RECORD OF TECHNICAL CHANGE

Technical Change No. DOE-LM/1555-2007 ROTC-2 Page 1 of 3
Activity Name Central Nevada Test Area – ROTC for the CADD/CAP Addendum Date June 12, 2013

Addendum to: Corrective Action Decision Document/Corrective Action Plan (CADD/CAP) for Corrective Action Unit (CAU) 443: Central Nevada Test Area (CNTA) - Subsurface, Nevada, DOE/NV-977 January 2008

Figure 7. Proposed locations of the three new alluvial wells and five seismic lines acquired in October 2007.

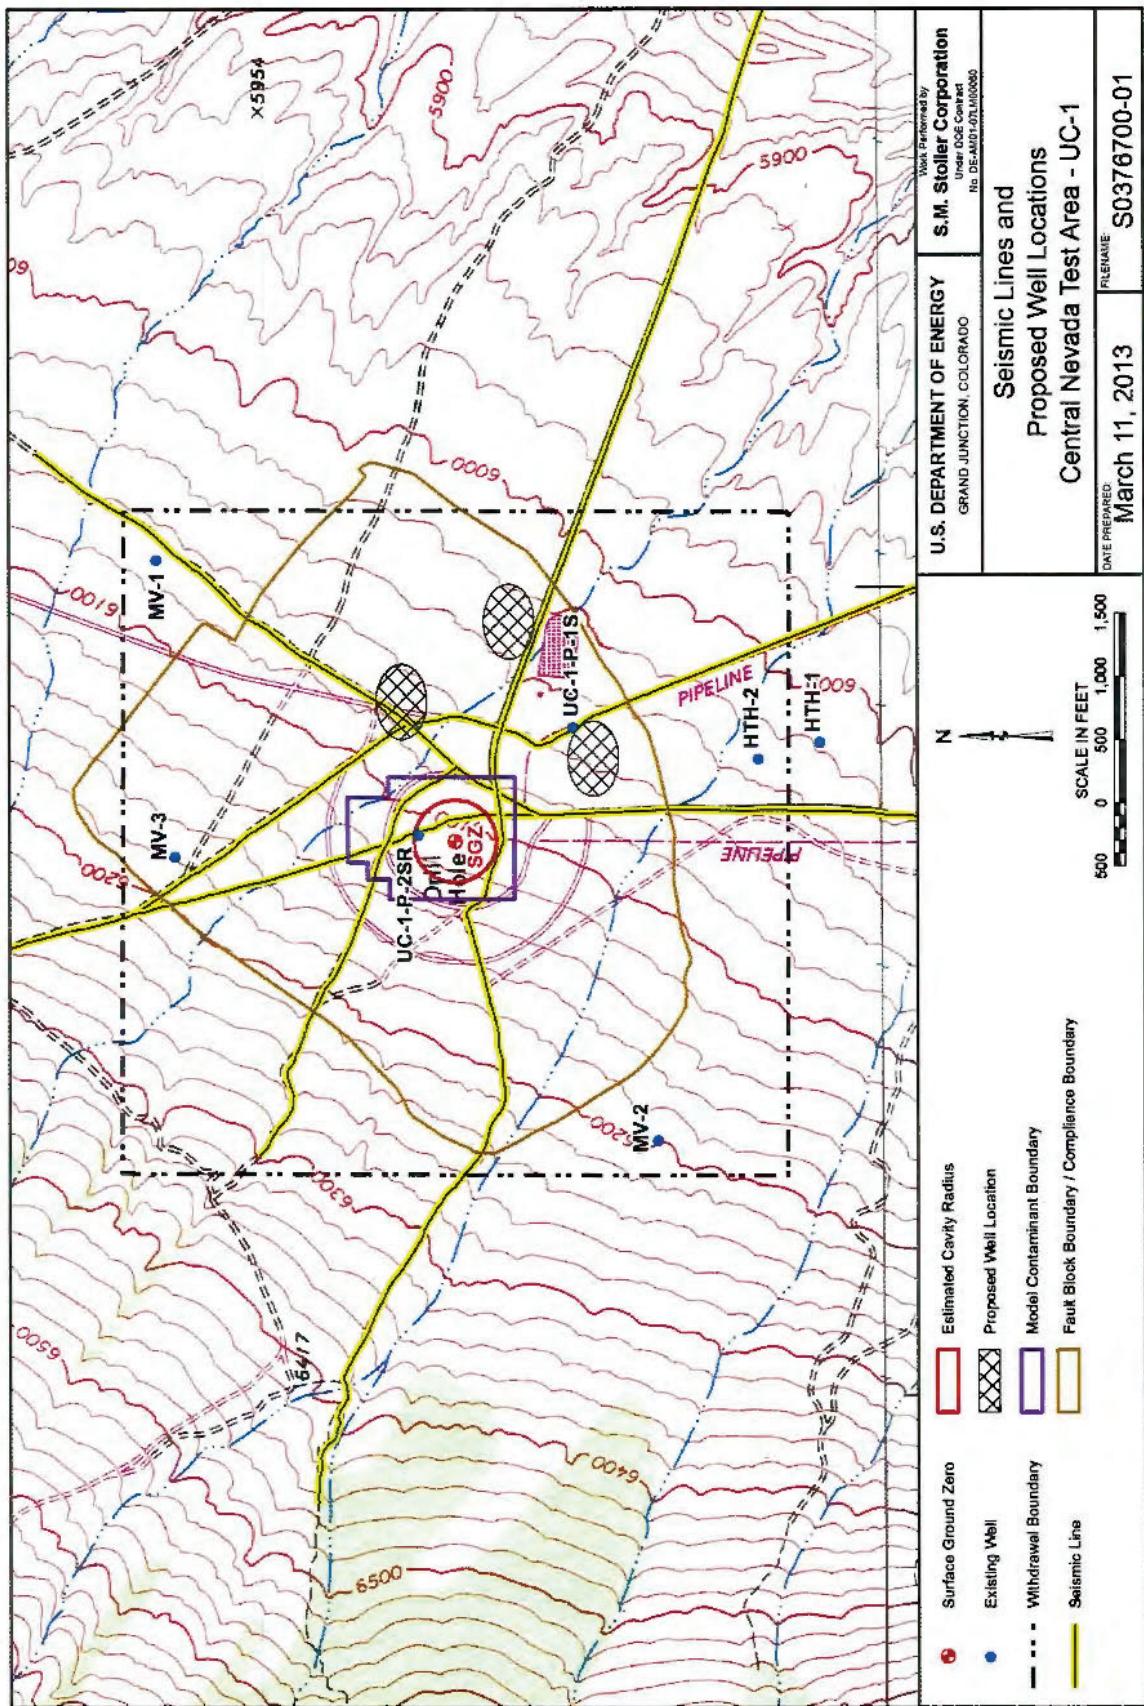
Page 12, Figure 7: The figure should be revised to include the proposed well location (MV-6) northeast of the detonation. The revised Figure 7 is provided as an attachment to this Record of Technical Change.

LM and NDEP agreed that a new monitoring well (MV-6) should be installed in the upper alluvium northeast of the

Figure 8. Project Schedule.

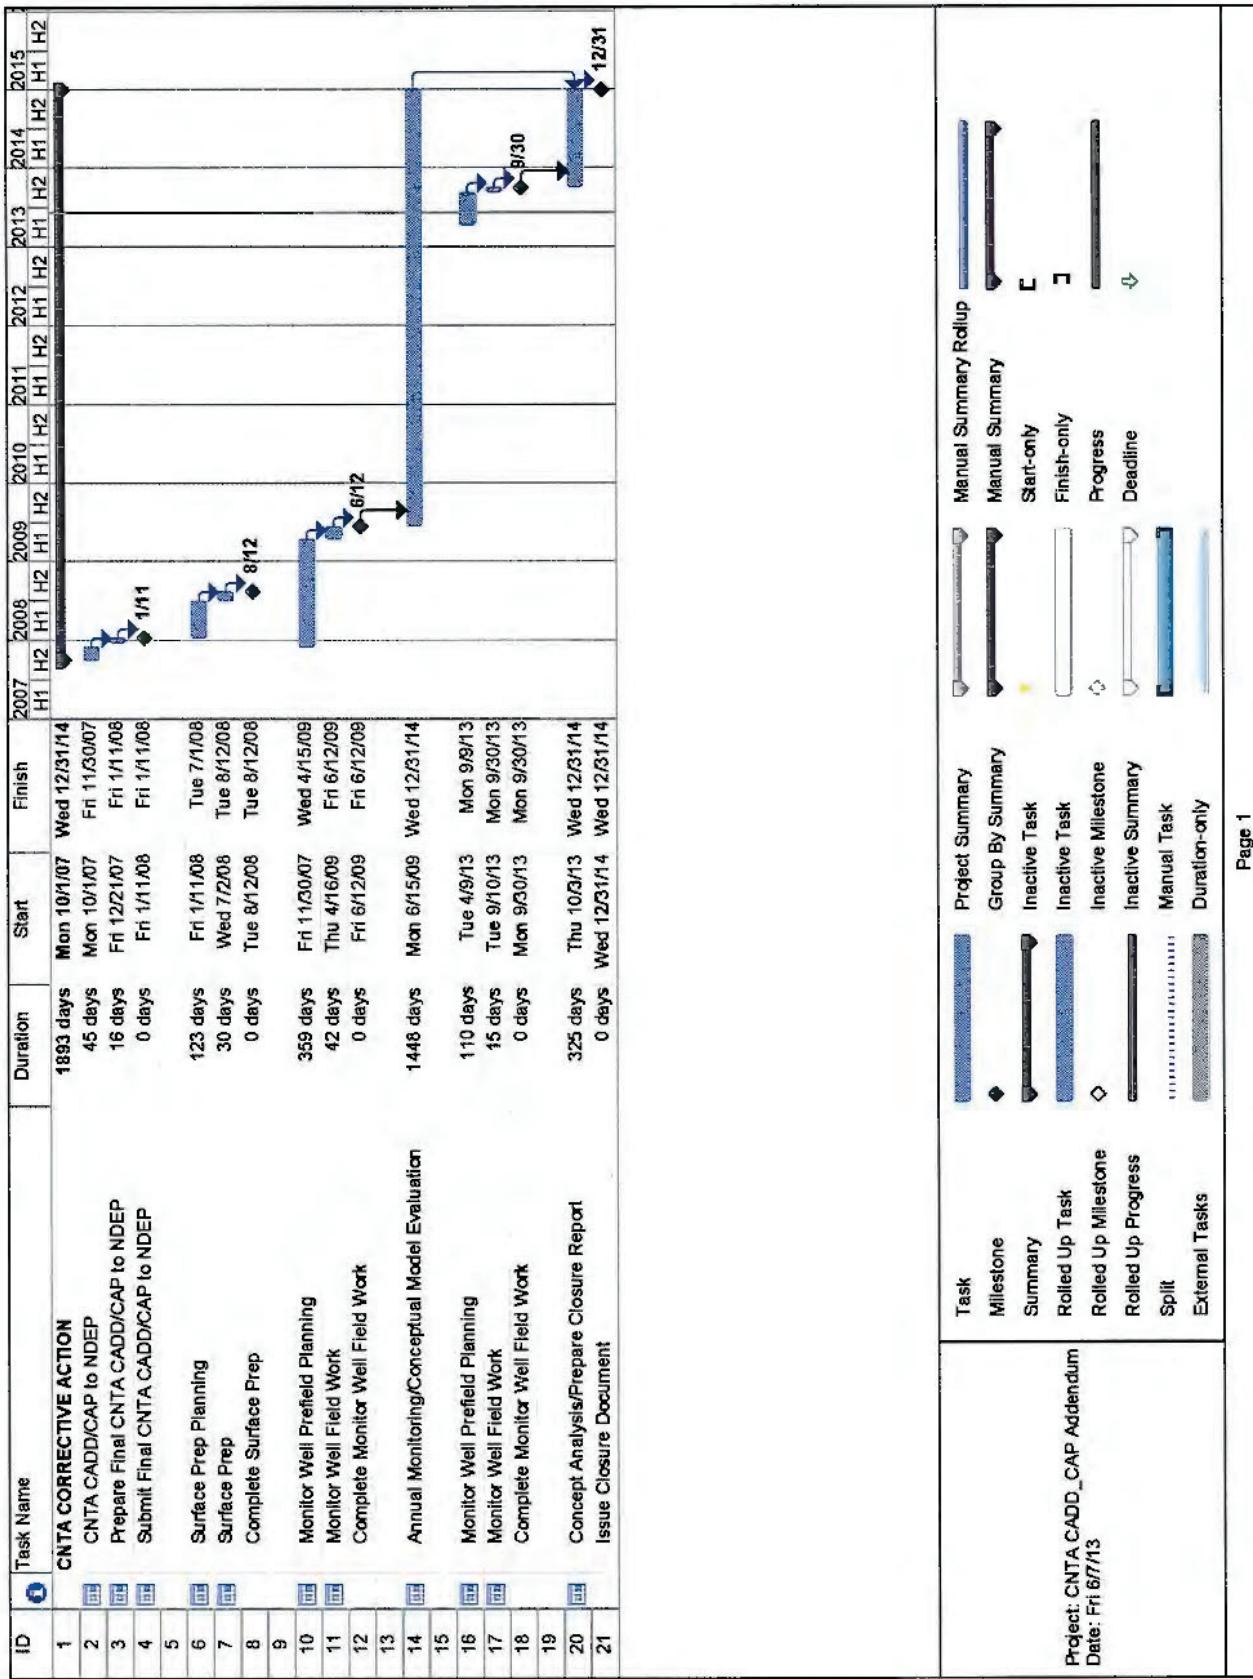
Page 16, Figure 8: The project schedule should be revised to include the installation of the new well (MV-6) and new dates for completing the Conceptual Model Evaluation and Closure Report. The revised Figure 8 is provided as an attachment to this Record of Technical Change.

LM and NDEP agreed that the schedule for monitoring well (MV-6) would be conditional based on funding.

Installation of the new monitoring well (MV-6) will increase the duration of the corrective actions at CNTA by approximately 264 business days or 370 calendar days. A revised schedule (Figure 8) of the corrective actions is provided as an attachment to this Record of Technical Change.

Figure C-4. Groundwater Flow Directions Estimated for Case 3.
Scenario for when groundwater levels in the area of the detonation recover.

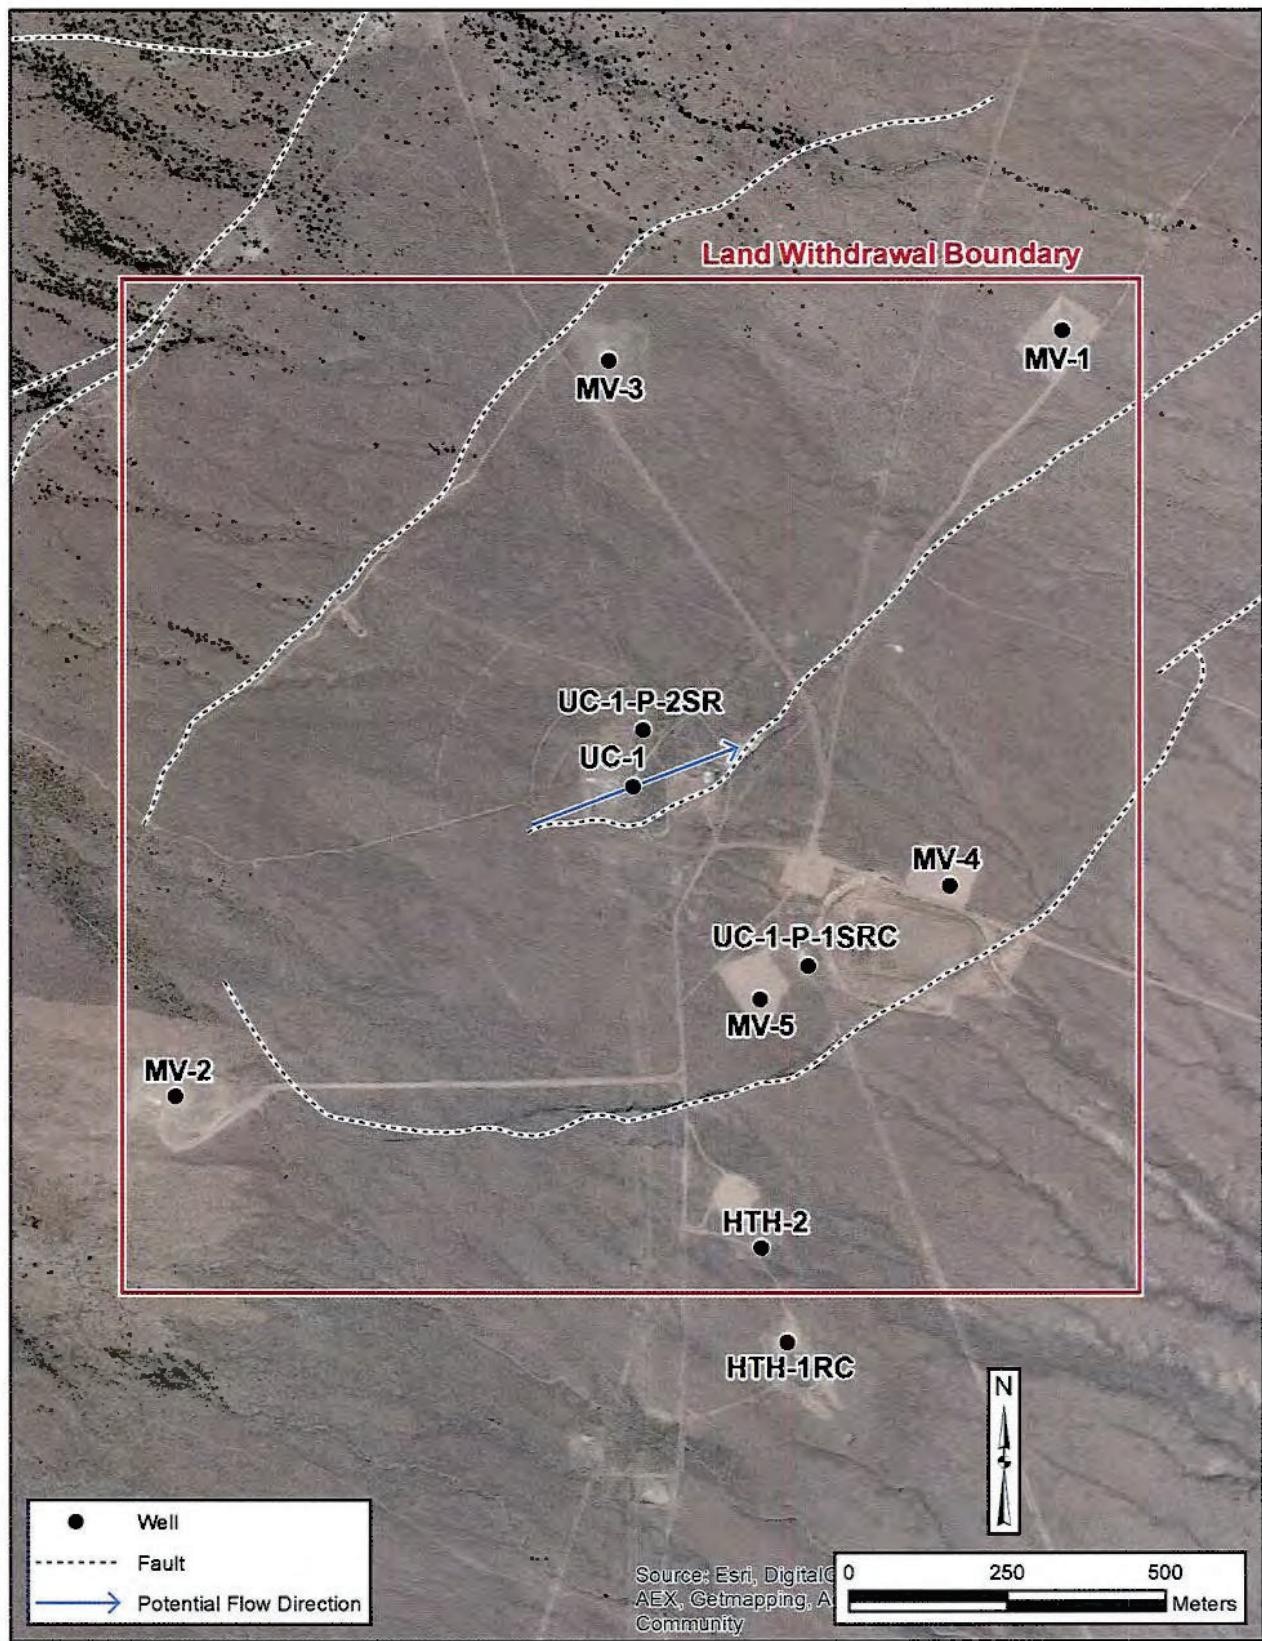
Appendix C, Page C-5, Section C3.0, Include the following sentences as the last paragraph on the page: "An additional case (Case 3) was developed to include a scenario for when groundwater levels in the area of the detonation recover. In this scenario, groundwater flow in the upper alluvial unit near the detonation is diverted by the southern graben fault that acts as a barrier to groundwater flow. This results in a groundwater flow near the detonation that is toward the east-northeast and is depicted in Figure C-4." Figure C-4 is provided as an attachment to this Record of Technical Change.

LM and NDEP agreed that when groundwater levels in the area of the detonation recover groundwater flow near the detonation may be diverted to the east-northeast by the southern graben fault and that the placement of well MV-6 is positioned to monitor this potential flow path.

Figure E-3. Generalized MV-6 Well Schematic.

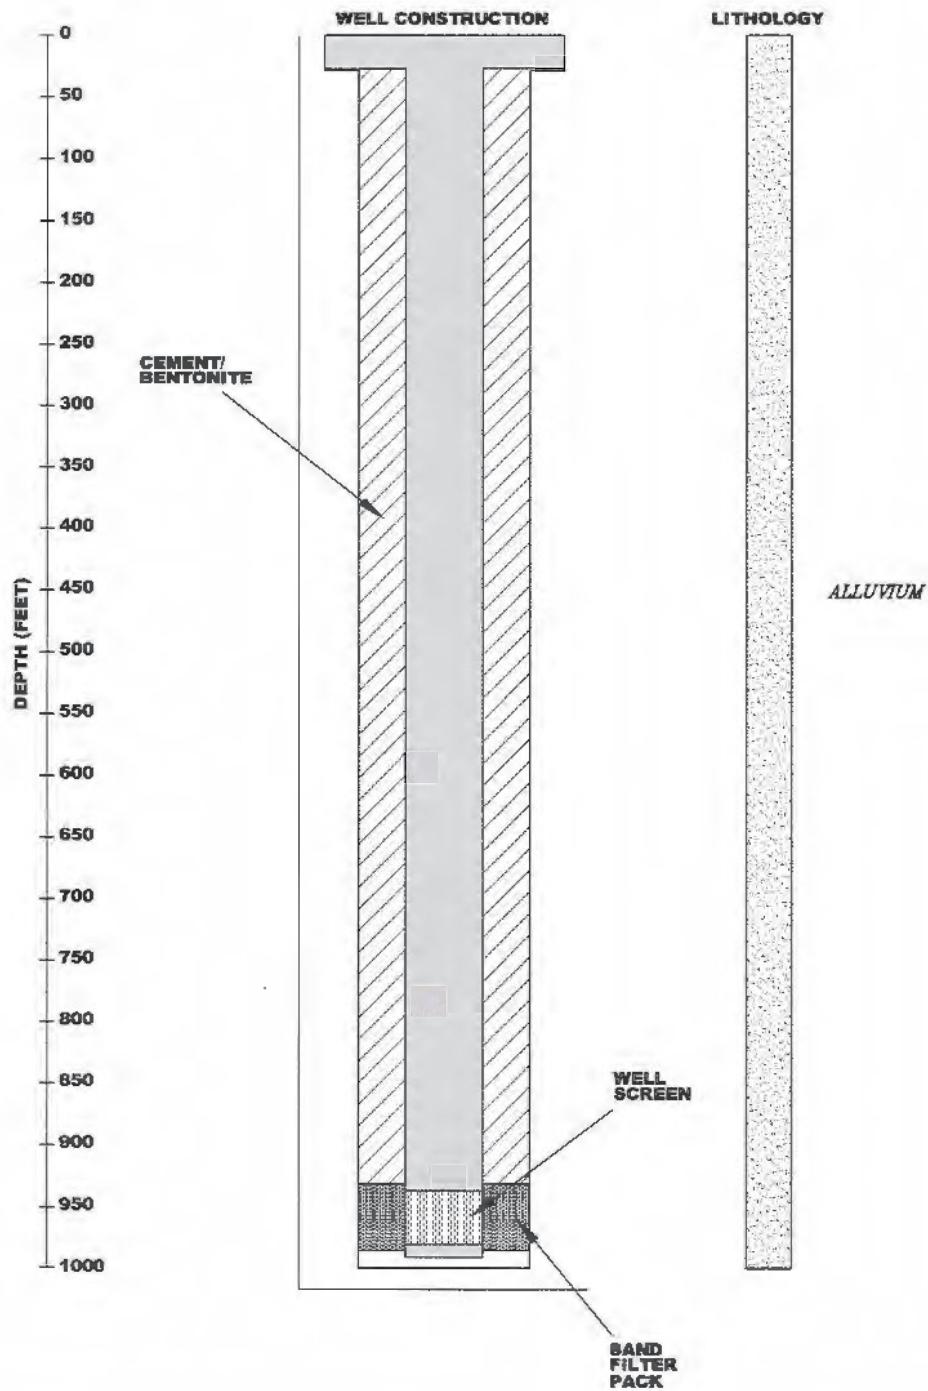
Page E-3, Appendix E: Include the following sentence as the last paragraph on the page: "The pre-drill plan is to install a well in the MV-6 borehole (Figure E-3)." Figure E-3 is provided as an attachment to this Record of Technical Change and

LM and NDEP agreed that monitoring well (MV-6) would be completed in the upper alluvium northeast of the detonation.

Figure 8. Project Schedule.

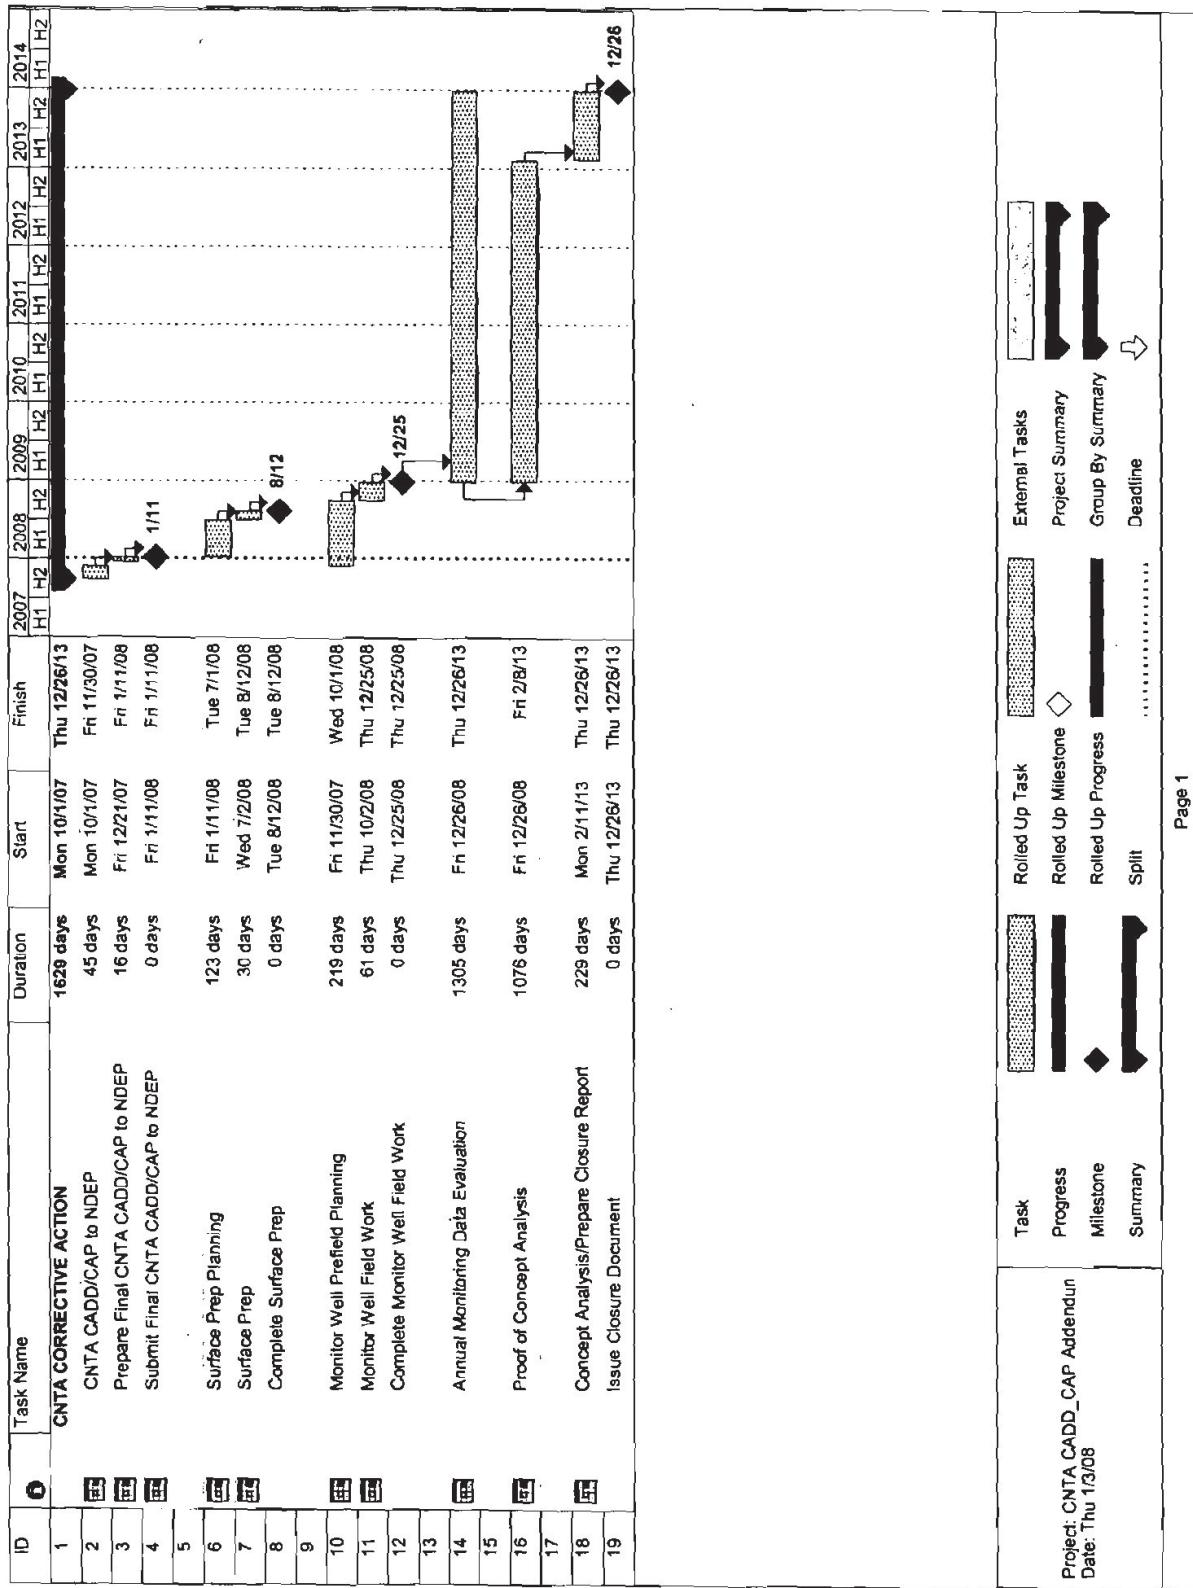
3. Figure 8 – This Figure lists the date for submittal of the Final CNTA CADD/CAP to NDEP as January 31, 2008. However, a November 9, 2007 letter from the NDEP to Mr. Jack Craig established the Milestone Deadline for Corrective Action Unit 443, Central Nevada Test Area – Subsurface Final CADD/CAP Addendum as January 11, 2008. Should the U.S. Department of Energy/Office of Legacy Management require an extension to this Milestone Deadline of January 11, 2008, such a request must be made of the NDEP pursuant to Subpart X.1 of the Federal Facility Agreement and Consent Order (FFACO).
